ADDENDUM No. 3

City of Moscow, ID Well 10 Development – Phase II

February 24, 2020

Addendum No. 3 to the **Moscow Well 10 Development – Phase II** Bidding Documents prepared by J-U-B ENGINEERS, Inc. is hereby submitted for use in bid preparation and Submittal.

CITY OF MOSCOW
 WELL 10 DEVELOPMENT - PHASE II
 CIVIL UTILITIES (CU)
 WATER UTILITY PLAN

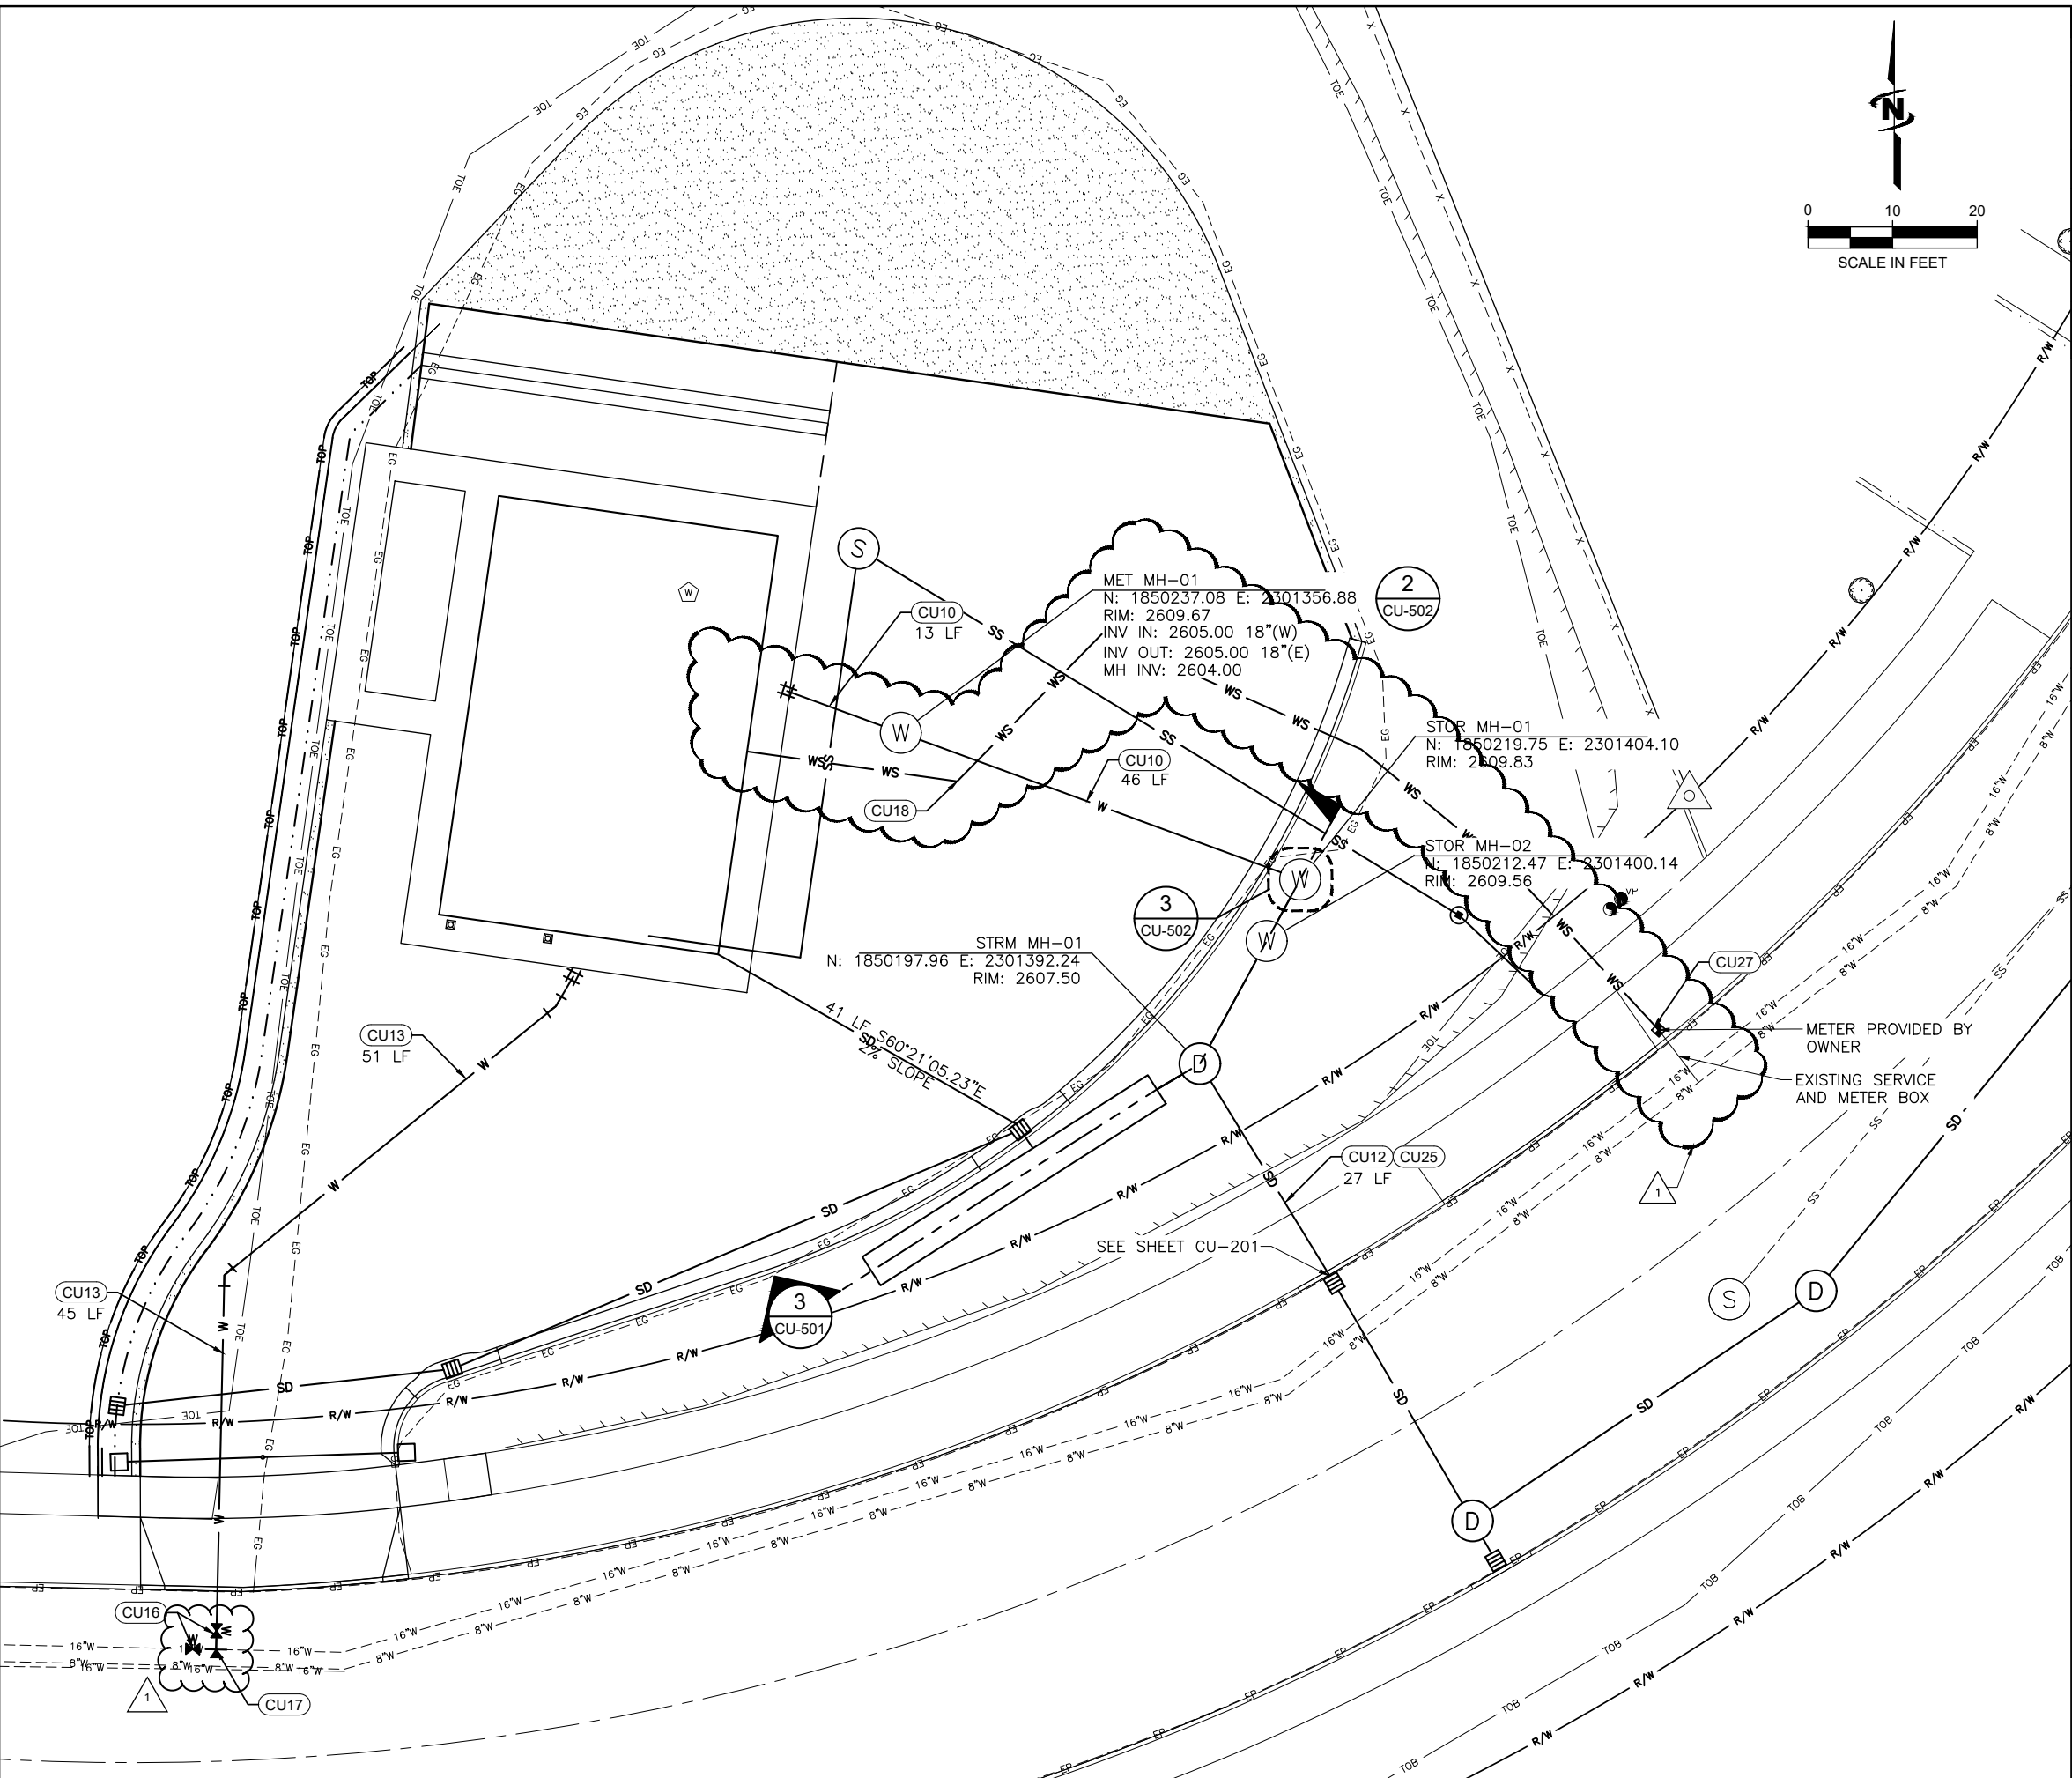
- **Modification:** Modify MET MH-01 Manhole information to replace “18”” with “10””.

7. Sheet CU-101, manhole MET MH-01, it shows 18” in and out pipe, but isn’t that 10”?
 - a. Yes, that is a 10” pipe in and out. See modification above.
8. CU-202, CB-3 and CB-4, are those hooded or non-hooded?
